Access Compliance Report

Public Rights-of-Way

(Curb Ramps)

Intersection ID: 42737	Main Street: CALDWELL_FOREST_DR	Cross Street: CARLEEN_WAY_DR	Location:	N
ADA ID: 449CBE1E5BC7	Ramp Type: PerpDiag	Initial Pass/Fail: Fail	Overall Compliance: No	Severity Score: 21.25

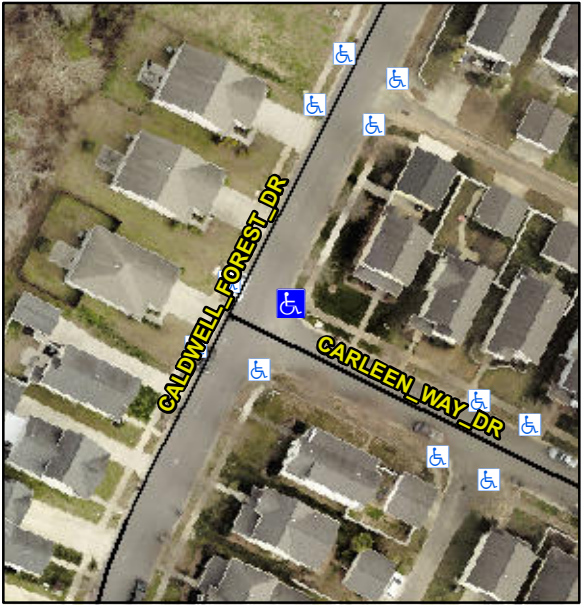
Codes/Mitigation Info/Possible Solution			Field Measurements/Component Compliance		
	Possible Solutions:		Compliance	Description	Data
	Remove & Replace Curb Ramp With Two New Directional Ramps or Equivalent.		N/A	Ramp Length (in)	56.0
			No	Ramp Width (in)	38.5
			N/A	Flare Type LT	N/A
			N/A	Flare Slope LT (%)	N/A
			N/A	Flare Traversable LT?	N/A
			N/A	Landing Length (in)	N/A
			N/A	Landing Width (in)	N/A
			N/A	Landing Slope (%)	N/A
			N/A	Landing X Slope (%)	N/A
<p>Surveyor Notes:</p> <p>N/A</p> <p>PROW/ADA:</p> <p>R304.5.1, R304.5.3</p>			N/A	Flare Type RT	N/A
			N/A	Flare Slope RT (%)	N/A
			N/A	Flare Traversable RT?	N/A
			N/A	DWS Provided?	N/A
			N/A	DWS Contrast?	N/A
			N/A	DWS Length (in)	N/A
			N/A	DWS Full Width?	N/A
			N/A	DWS Offset (in)	N/A
			N/A	Shared Landing?	N/A
			N/A	Gutter Ponding?	N/A
			N/A	Gutter Lip Ht (in)	N/A
			N/A	Painted X Walk1?	No
				X Walk 1 Direction	To W
			N/A	X Walk 1 Width (in)	N/A

X Walk 1 Slope (%)	1.0
				X Walk 1 X Slope (%)	2.1
			N/A	Ramp inside XWalk1?	N/A
				Road Slope (%)	1.4
				Road X Slope (%)	0.8
			N/A	Any Obstructions?	N/A
				Obstruction Type	
Total Cost:		\$ 3200.00			
			N/A		N/A
			Yes	Surface Condition? (G/P)	Good
